6.0 KEY REVISIONS

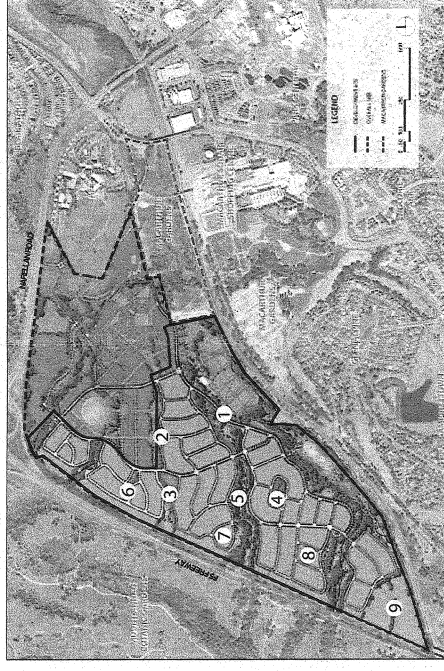
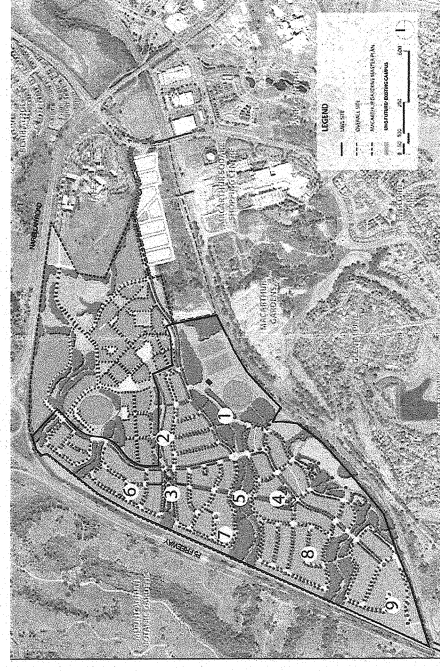
ADOPTED 2007 MASTER PLAN	REVISED 2011 MASTER PLAN
1	Collector road	Downgraded to a low-key emergency access, reducing construction costs and improving open space connectivity
2	Park edge road	Removed to create a naturalistic, pedestrian orientated linear park providing an improved transition between student accommodation and new housing
3	Hill-Top Park 1	Reconfigured to create a more defined interface between the public domain and adjoining houses
4	Hill-Top Park 2	Located on the collector road, offering a site for a potential bus stop and views to the lake and highly integrated into the village
5	Riparian Park	Creates a strong physical and visual connection between the ridge-top parks with a bridge crossing on a strong axis of realigned thoroughfares
6	Small open space	Replaced with stronger connections to Ridge-Top Park and Riparian Parkland
7	Street down contours	Replaced by a pedestrian path, significantly reducing cut and fill requirements

8	Street	Rationalised to avoid streets running down steeper contours, reducing cut and fill costs and concealing changes to natural landform (away from the public streetscape)
9	Large lots	Replaced with traditional lots better suited to broader housing needs, with access by a series of streets, closes and pedestrian passages
